AMENDMENT NO. 1 APRIL 1973
TO
IS : 5840 (Part I)-1970 DIMENSIONS OF CATHODE-RAY TUBES
PART I TUBE OUTLINES

Addendum

4. Television Picture Tubes

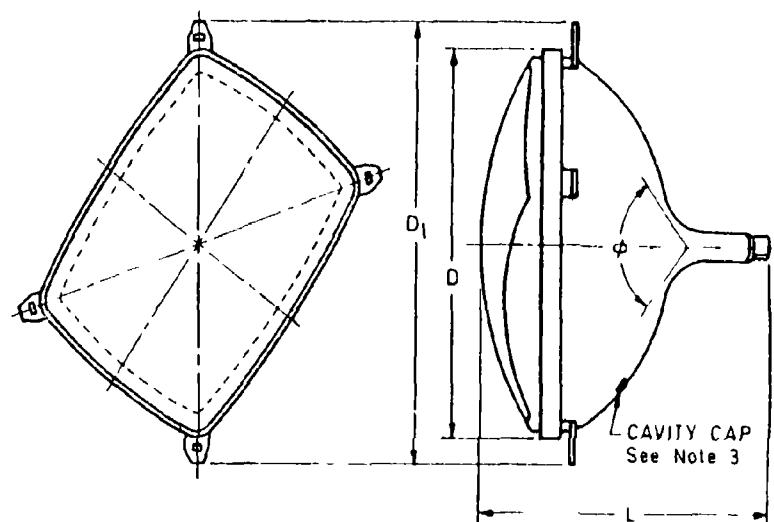
(Page 2, clause 3) — Add the following new clause after 3:

Size of the Tube Ref Letter	470 (see Note 5)					500					590 (see Note 5)					610				
	Min	Nom	Max	Angle in deg		Min	Nom	Max	Angle in deg		Min	Nom	Max	Angle in deg		Min	Nom	Max	Angle in deg	
				Min	Nom				Min	Nom				Min	Nom				Min	Nom
D		470	—	—	—	—	510	—	—	—	—	590	—	—	—	—	610	—	—	—
D ₁	—	—	521	—	—	I	—	570	—	—	I	—	685	—	—	I	—	675	—	I
L	—	295	305	—	—	—	311	318	—	—	—	358	366	—	—	—	362	370	—	—
phi	—	—	—	110	114	—	—	—	110	114	—	—	—	110	114	—	—	—	110	114

Note 1 — This dimension includes the provisions for implosion protection system.

Note 2 — The shapes shown are typical and not obligatory

Note 5 — These tubes are meant for replacement purposes only and will be withdrawn in due course.
